Tintenbar to Ewingsdale

Upgrading the Pacific Highway

Environmental Assessment
Submissions Report and
Preferred Project Report

May 2009

Figure 4.1a Preferred project

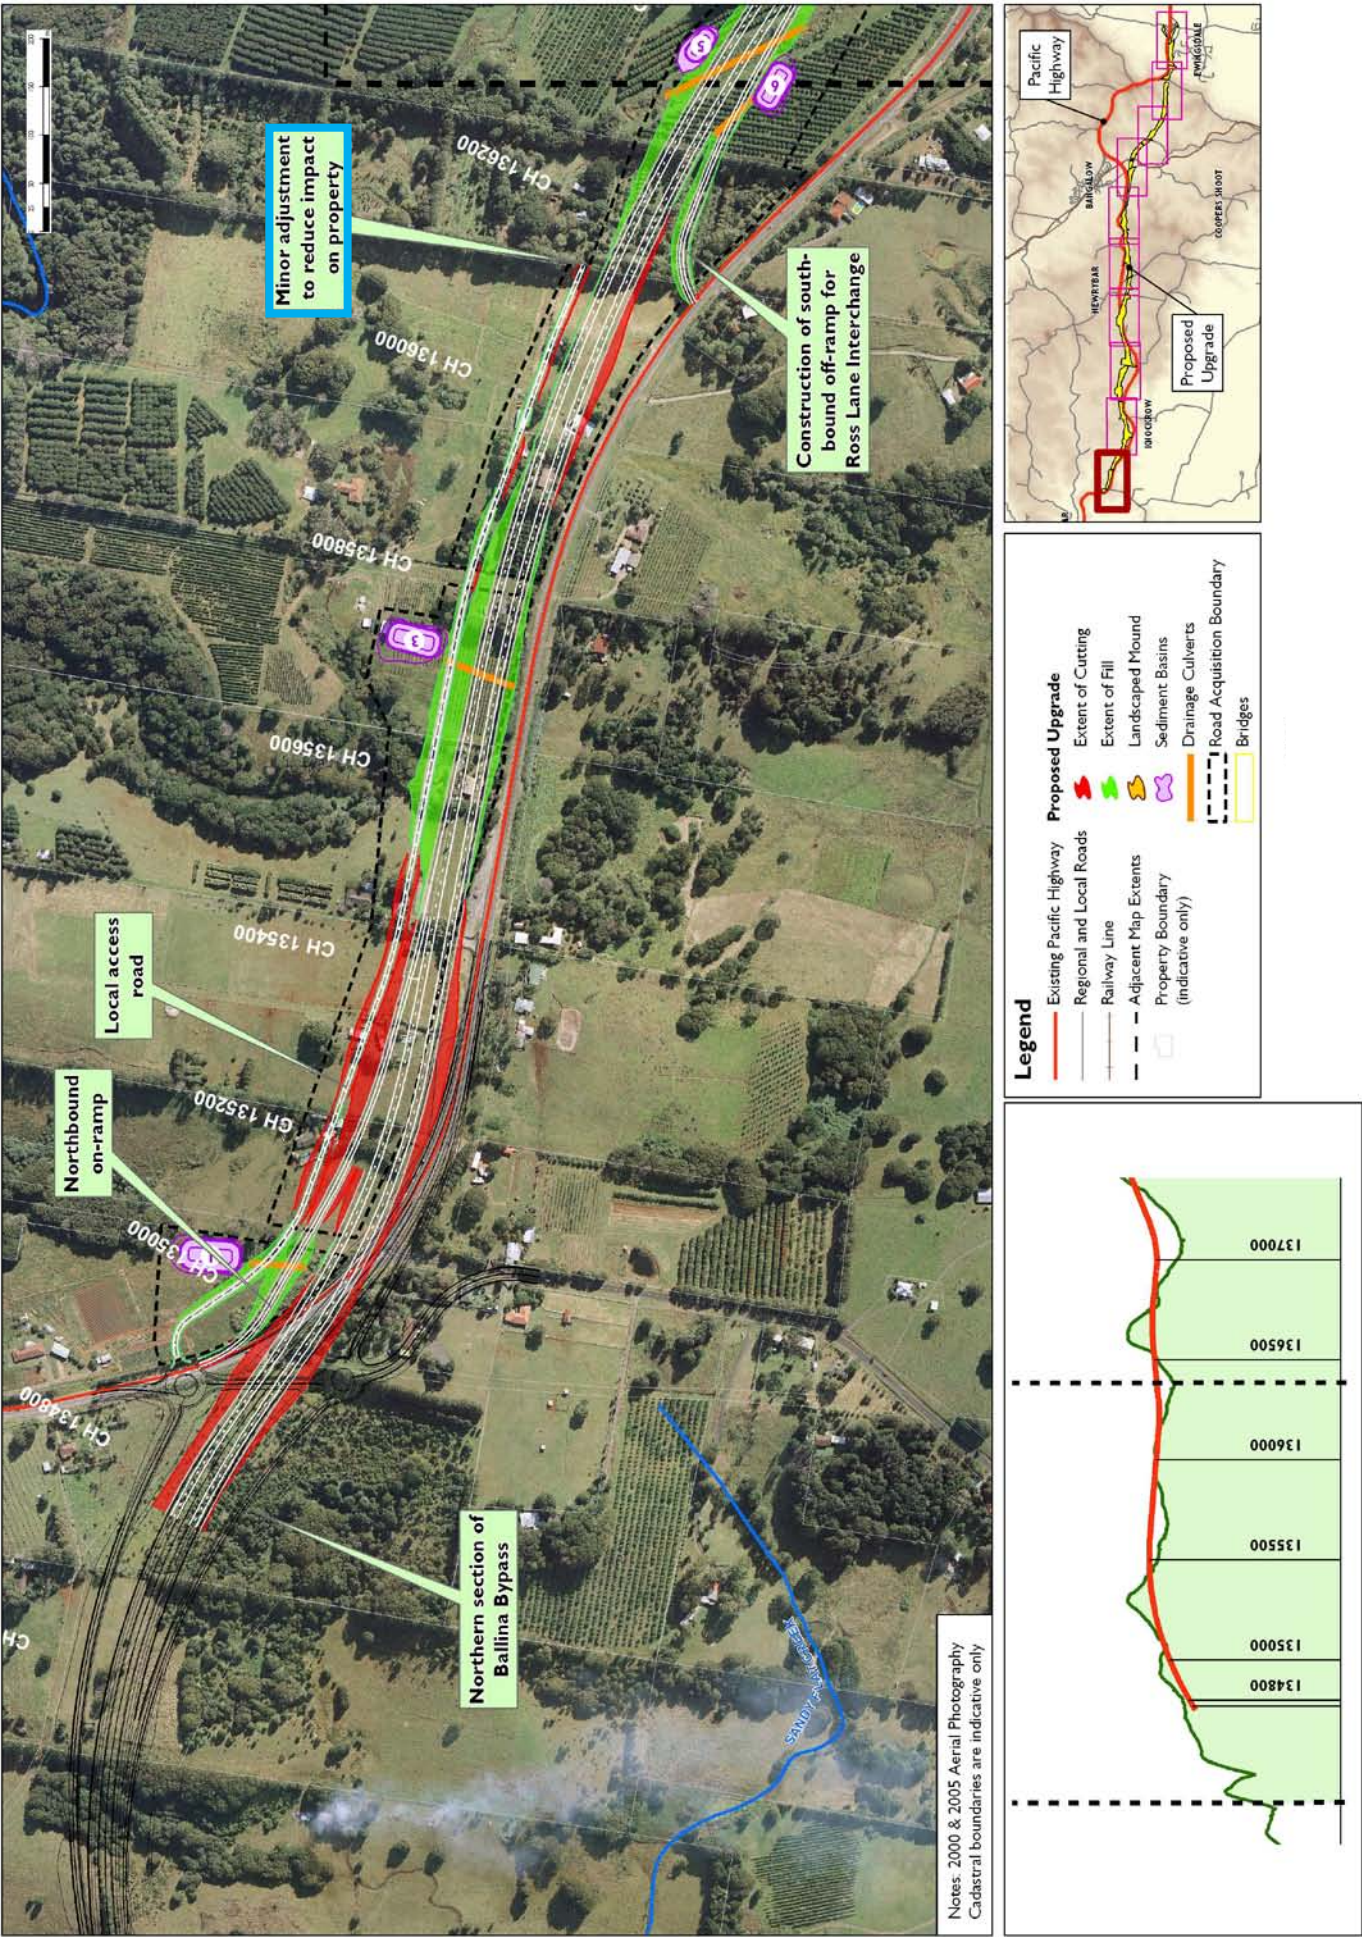
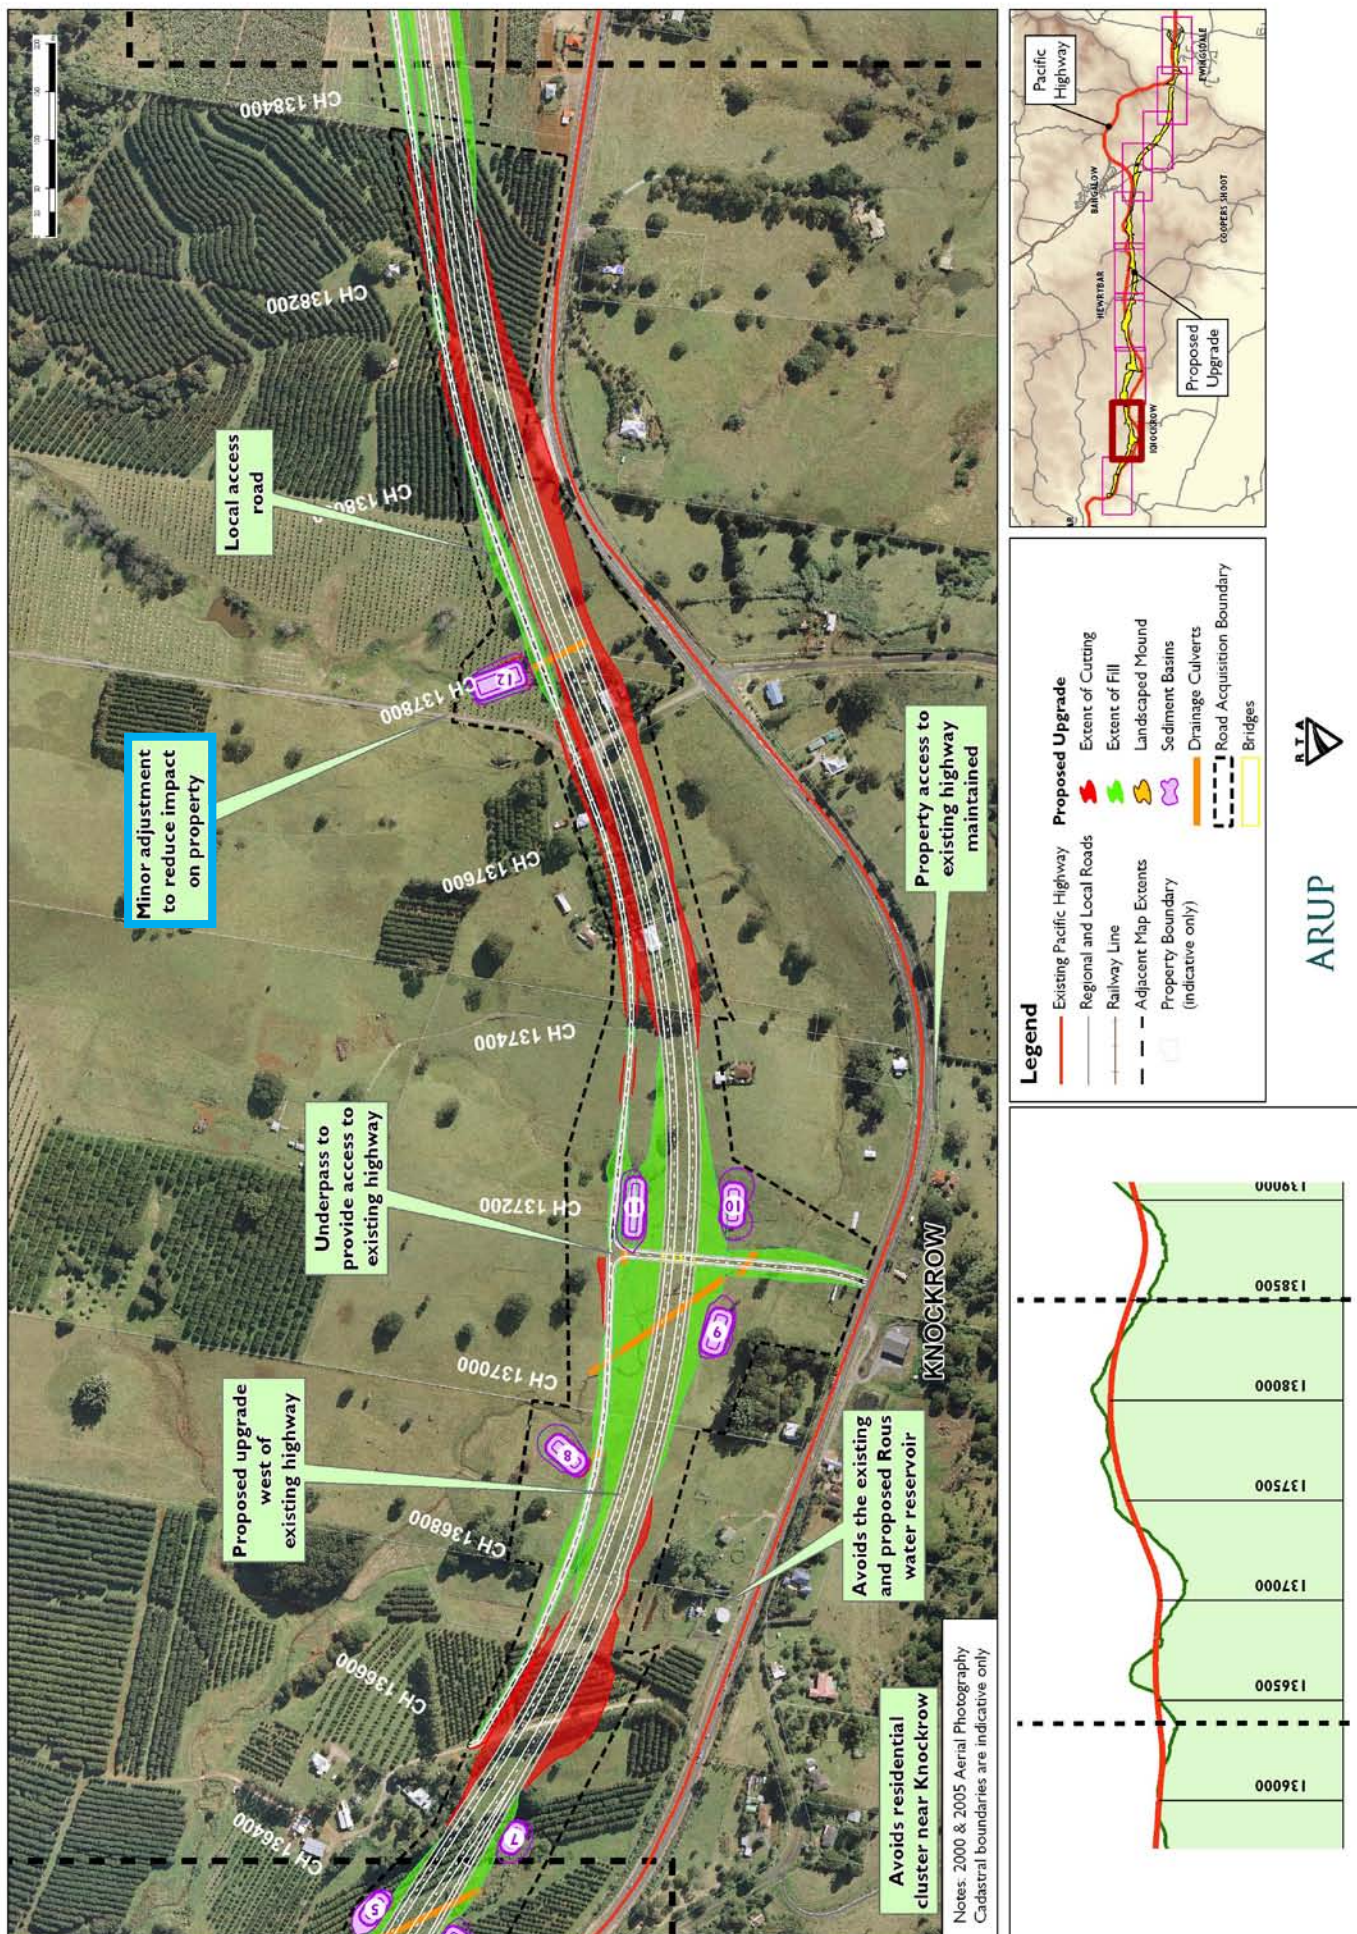
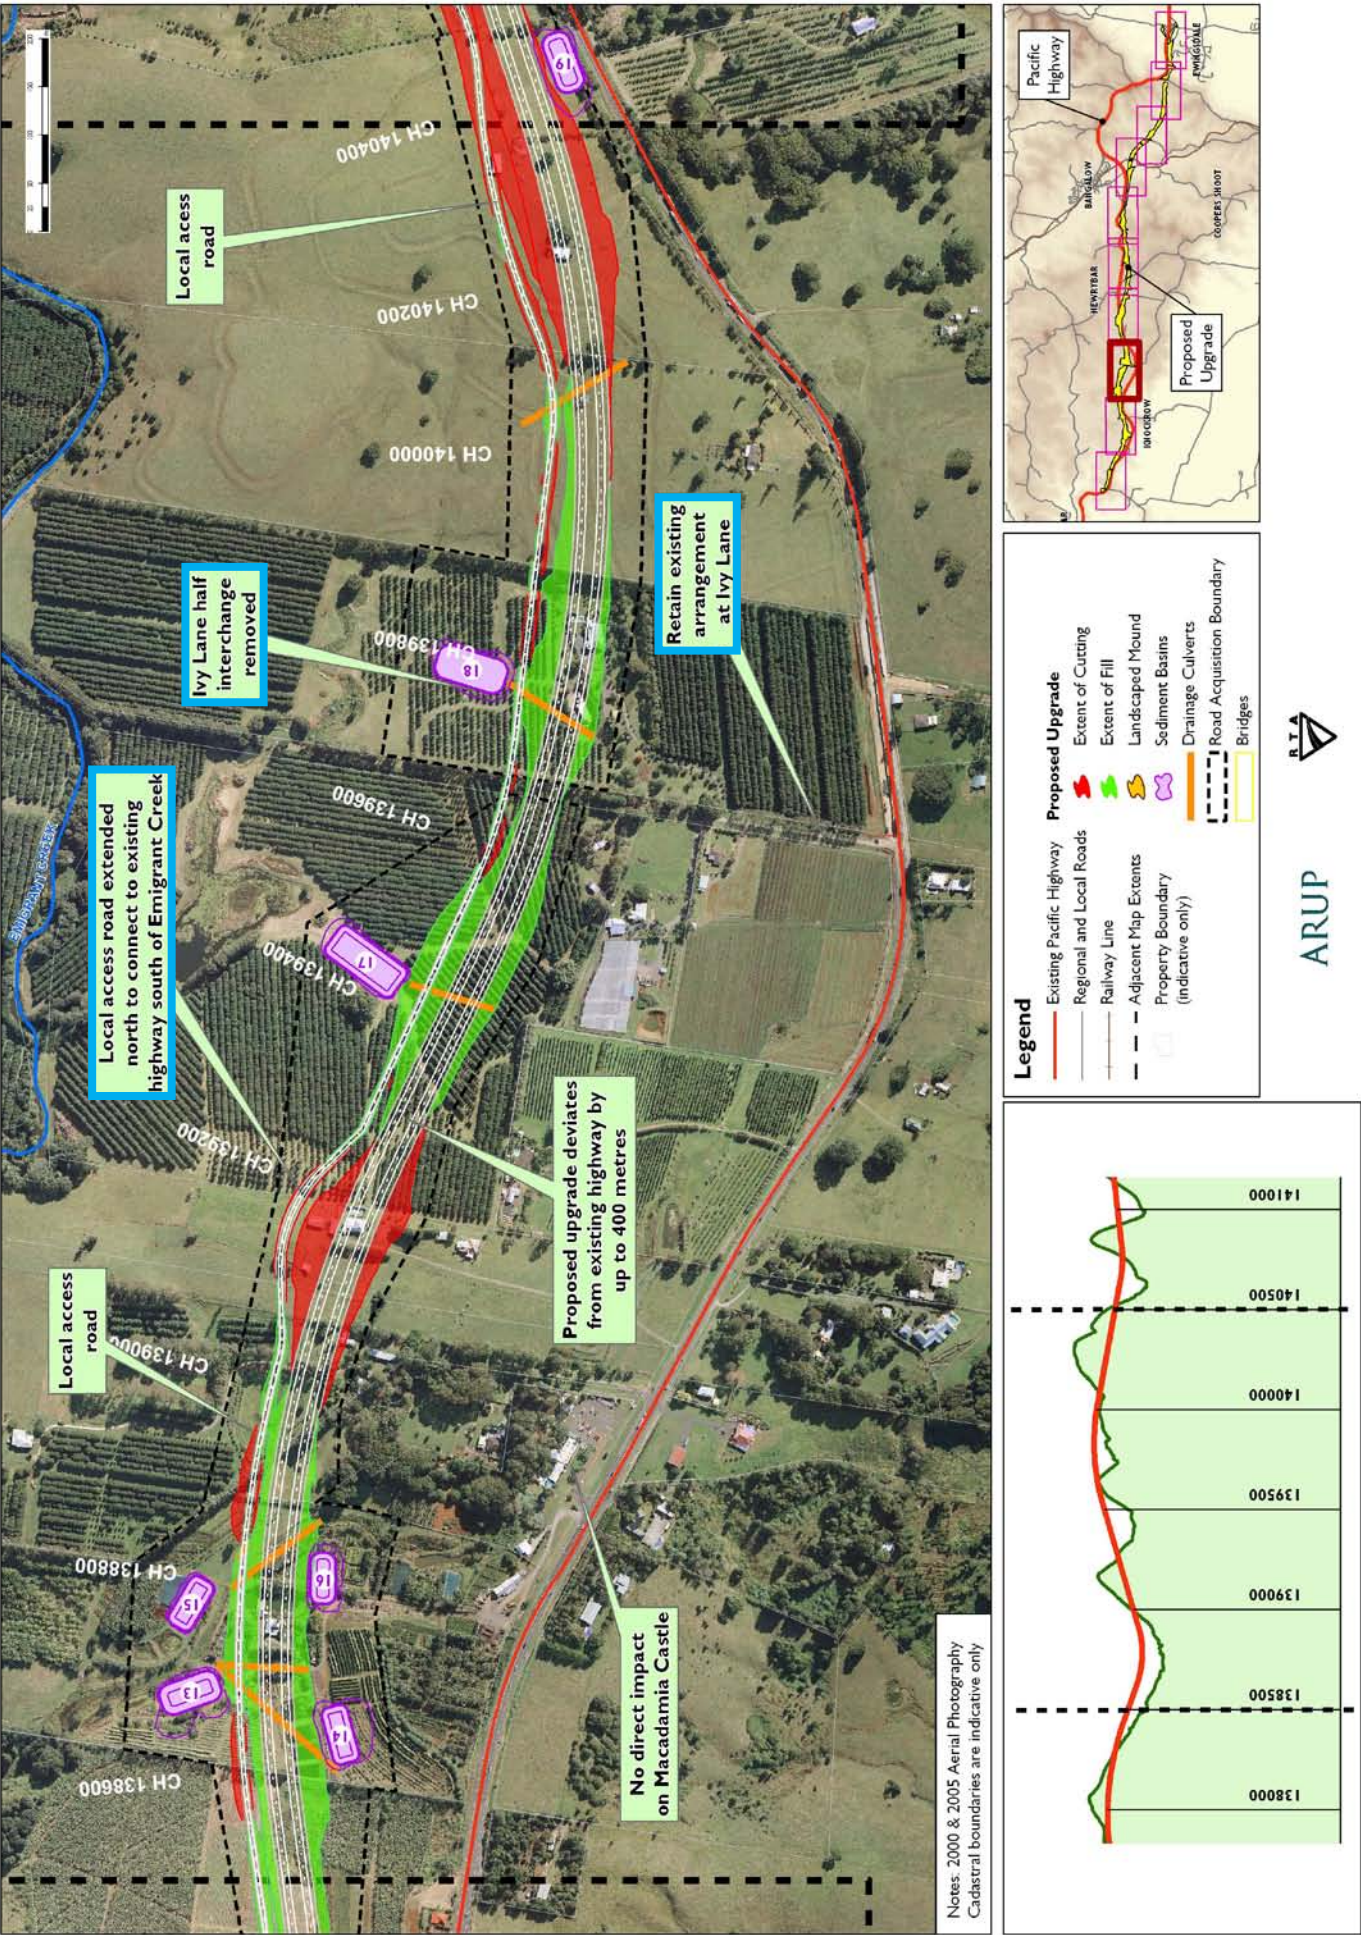
- > Concern over increased traffic on local roads
- > Concern over potential increased noise impacts.
- > Concern over visual and light spill impacts.
- > Questioning of the justification of the interchange in light of the projected level of use.

After further detailed consideration, the RTA has determined that the Ivy Lane interchange be removed from the proposed upgrade. The removal of the interchange is discussed in detail in Section 4.1 as part of the preferred project report.

As well as the interchange itself, the underpass at Ivy Lane would also be removed from the proposal and the local access road arrangements on the western side of the upgrade would be amended to provide access to the properties on that side. The altered configuration is shown in figure 4.1c.
